## Author Response to Reviews of

# Under-ice acoustic navigation using real time model-aided range estimation

E. Bhatt, O. Viquez, H. Schmidt

*Journal of the Acoustical Society of America*

### 2.4 line 89 → 126 (pg. 8)

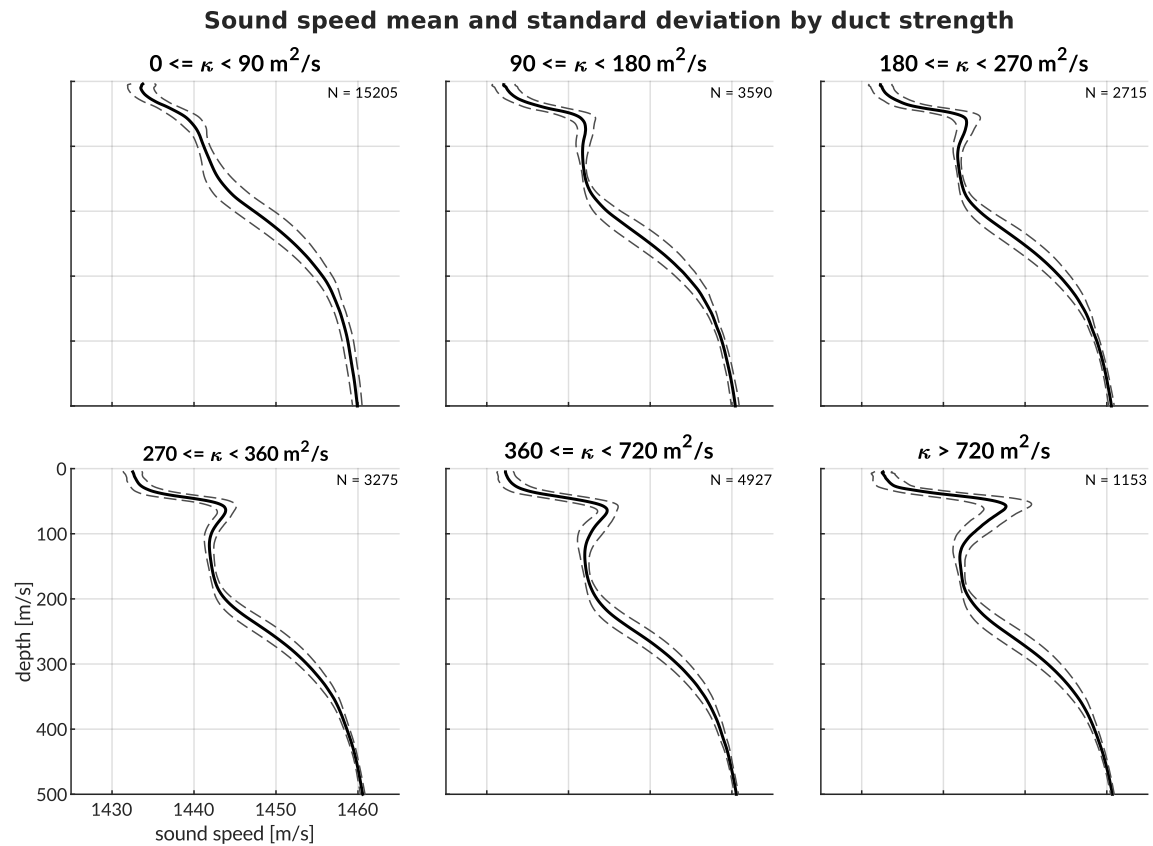
*Is the 'lens' the warm water? Or a combination of layers? What does 'lens' mean acoustically? Normally in ocean acoustics people refer to ducts and layers.*

Please see comment 2.1.
